**MEETING OF
THE HISTORIC DISTRICT COMMISSION
PORTSMOUTH, NEW HAMPSHIRE
EILEEN DONDERO FOLEY COUNCIL CHAMBERS**

January 08, 2025

AGENDA(revised on January 03, 2025)

**MINUTES OF
THE HISTORIC DISTRICT COMMISSION
PORTSMOUTH, NEW HAMPSHIRE
EILEEN DONDERO FOLEY COUNCIL CHAMBERS**

| | OPTION 01 - OPENING DETAILS | Project Number: 24064 Date: 12/13/2024 Drawn By: RD Checked By: MG |

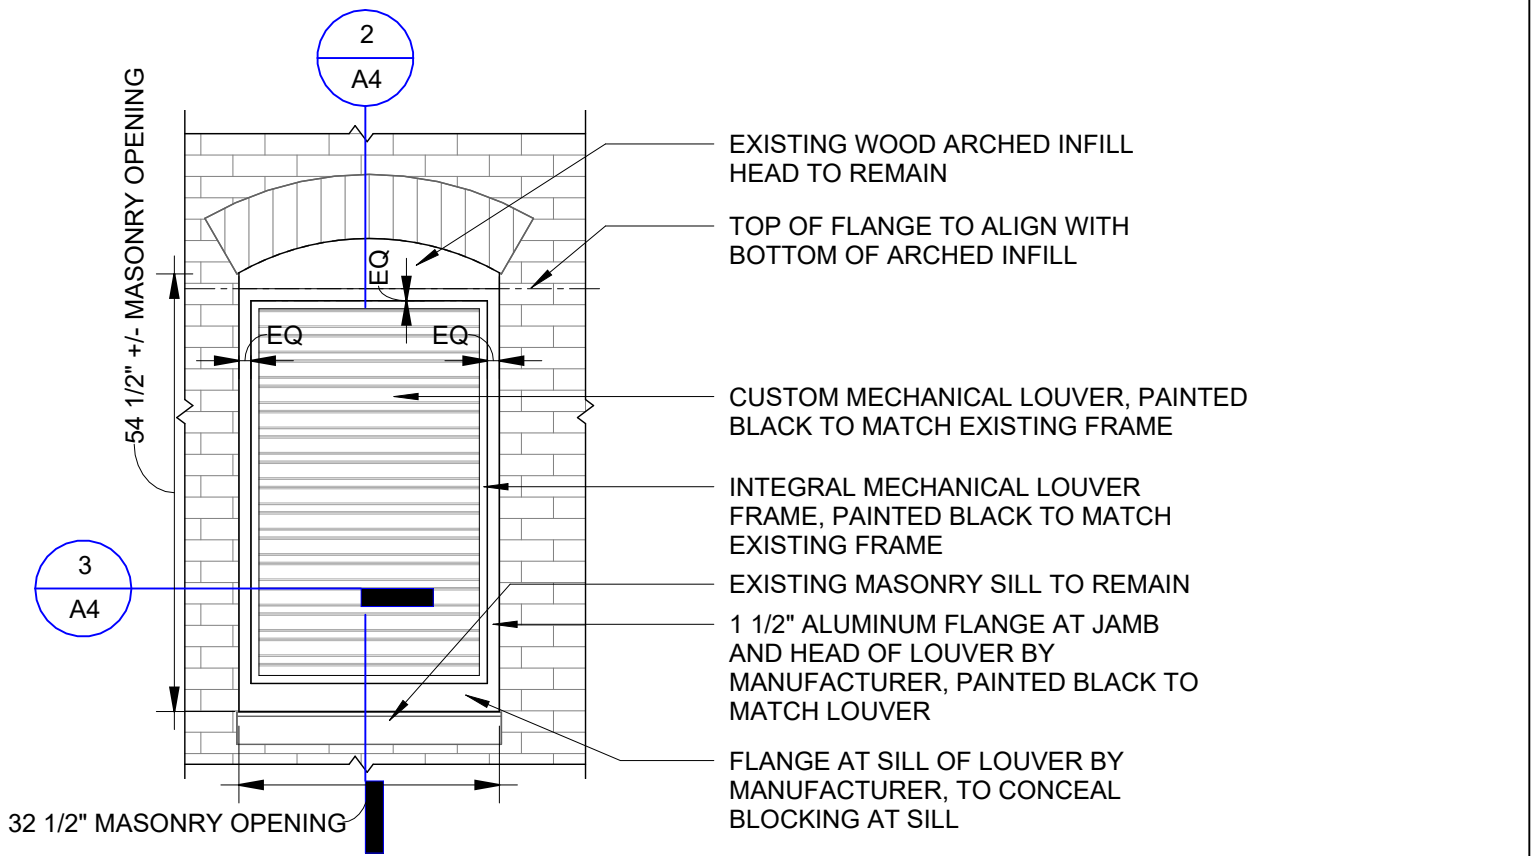
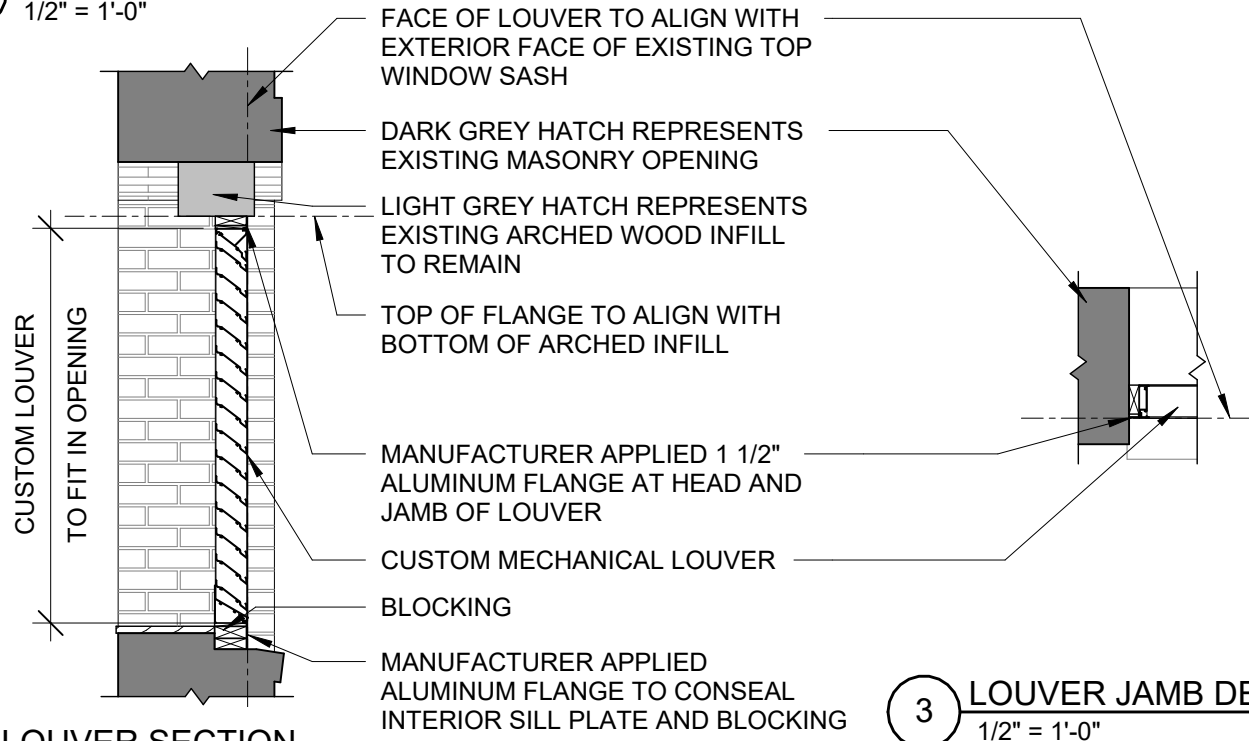
Option 01: Design team preferred option for weather tightness and aesthetics. The existing window sashes and frames would be removed as previously proposed on December 4th. The existing infilled arched head element would remain in place and the opening would be filled with the proposed louver with an attached flange. The exterior face of the louver will align in the same plane as the removed top sash of the window. This louver provides slightly more free area than required but was selected to fit more appropriately into the existing opening without providing excess infill or requiring the enlargement of the masonry opening. Sheet A4 provides details regarding this approach.

| | | A4 Scale 1/2" = 1'-0" |

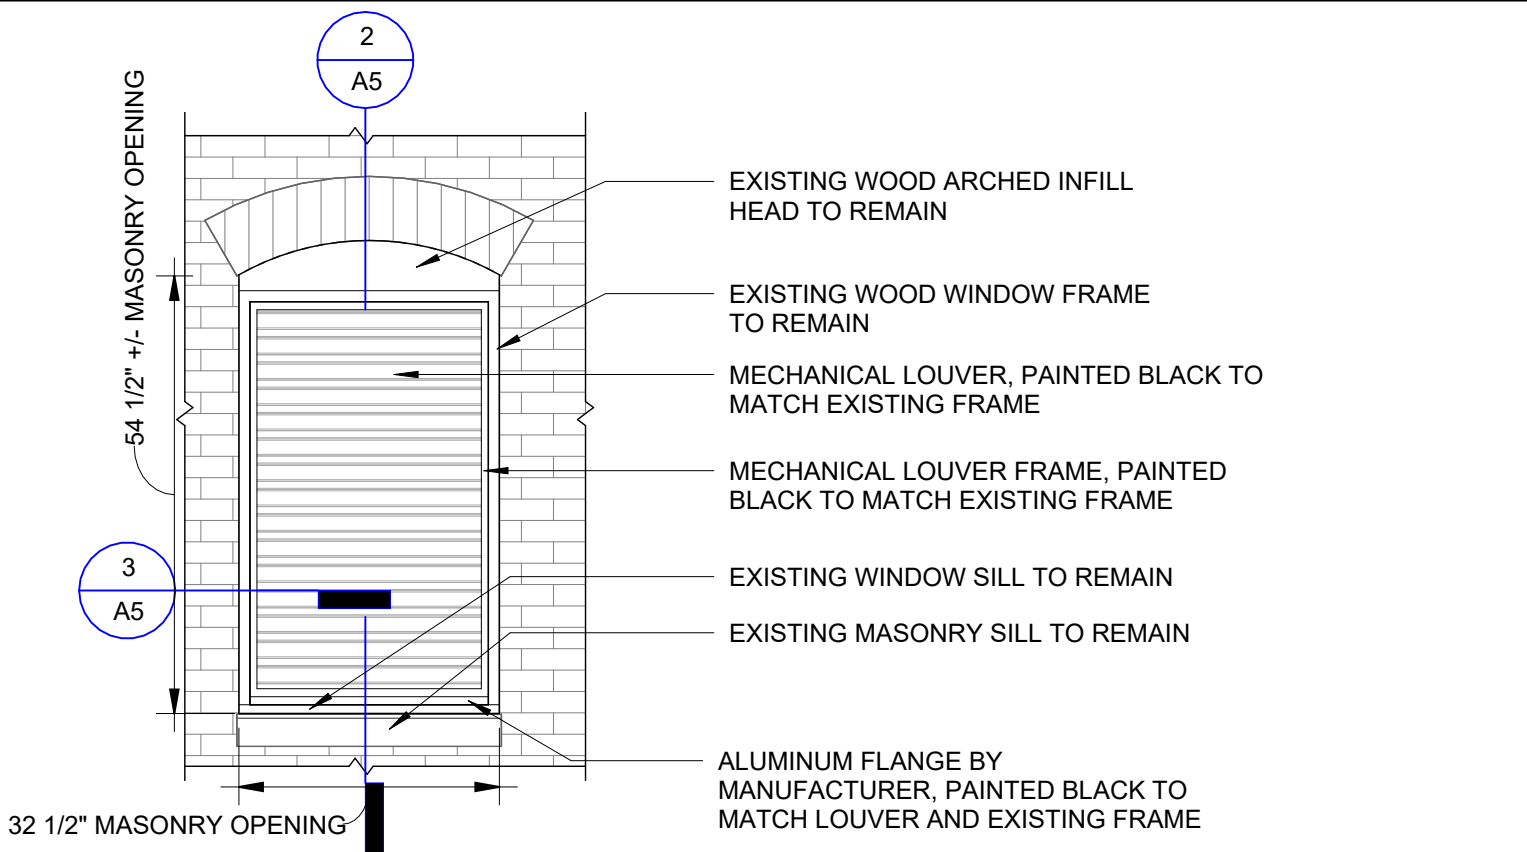
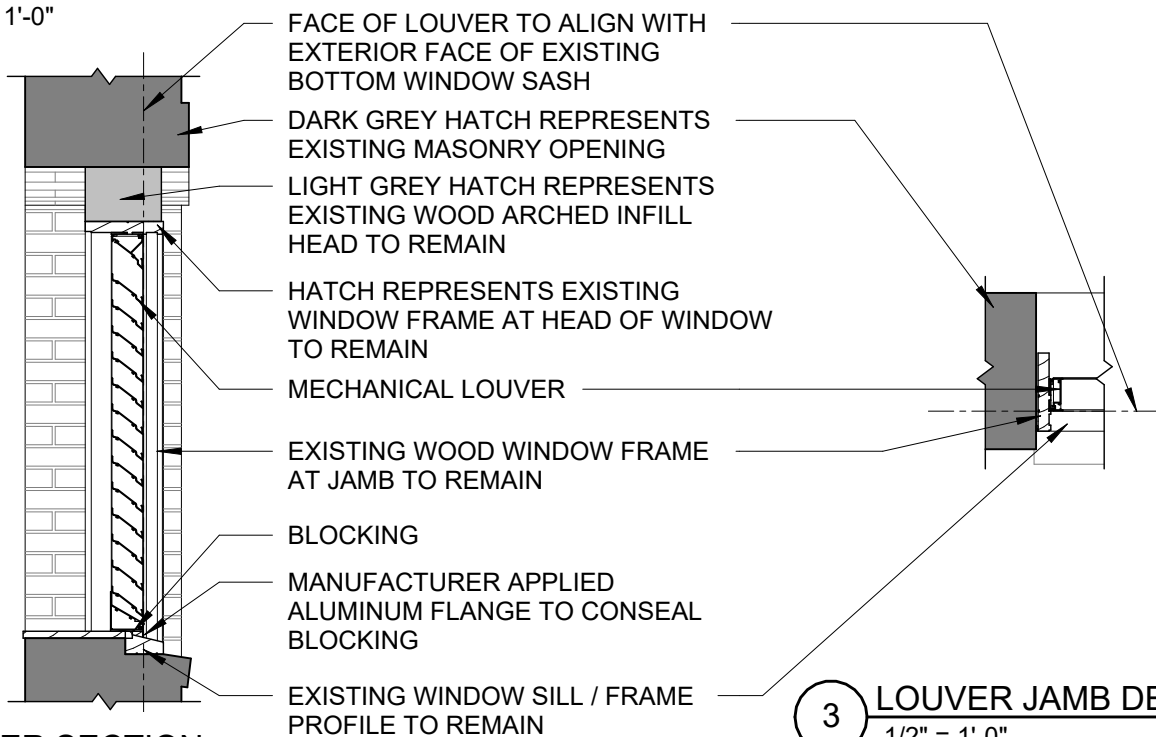
Option 02: The existing sashes of the windows will be removed. The existing infilled arched portion of the opening and window frame will remain in place. The clear dimension of the existing window frame is 29 ¼” wide by 49 ¾” tall. The louver for this option would be custom sized to fit within this frame. To avoid exposing the interior portion of the window frame to exterior elements (rain and snow), the exterior face of the louver will align in the same plane as the removed bottom sash of the window. Portsmouth Architects is concerned with weather tightness with this approach due to fact this is an unusual construction detail. Below is a rendering done by the contractor illustrating the louver. This rendering illustrates only 1 of the openings being replaced to be compared to the adjacent existing opening, it is still our intention to replace both windows. Sheet A5 provides details regarding this approach.

HAVEN SCHOOL CONDO PROJECT - UNIT 4 - FLOOR PLANS WITH VENT PROPOSAL

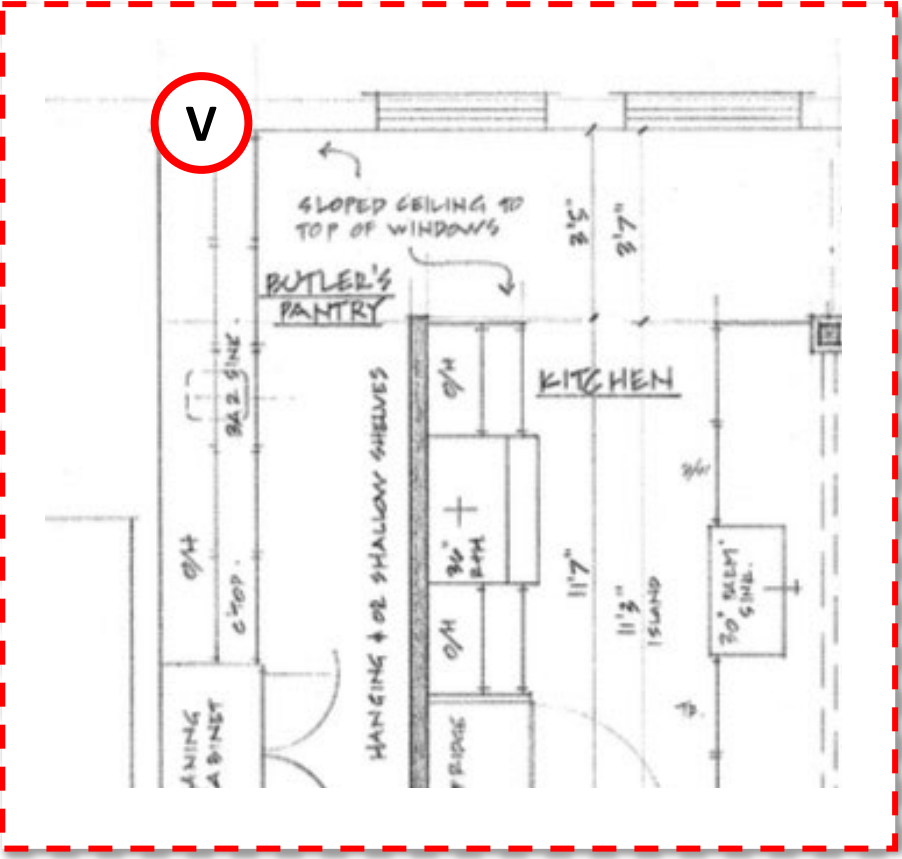
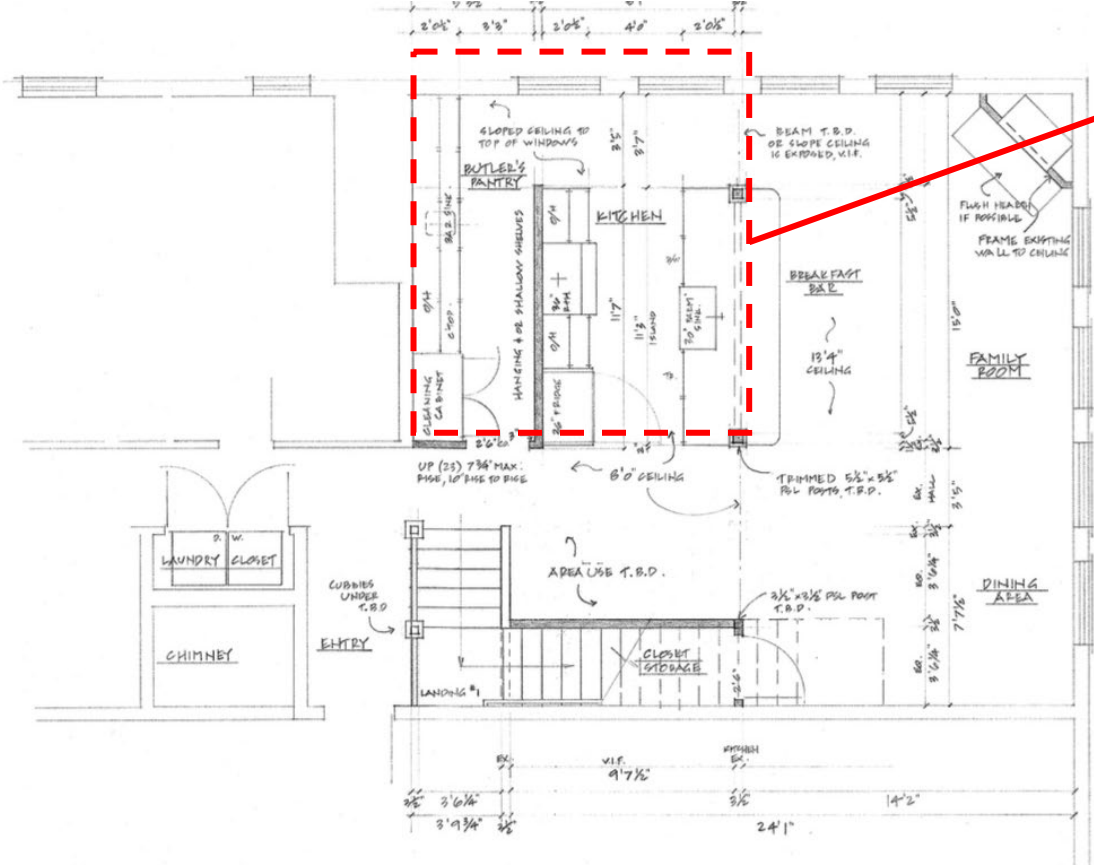
The proposed work includes the addition of a vent on the side of the building facing the parking lot, located on the second floor and positioned beneath the roofline. The renovation and associated work have been planned with careful attention to maintain the building's historic character and aesthetic.

V Proposed location of vent
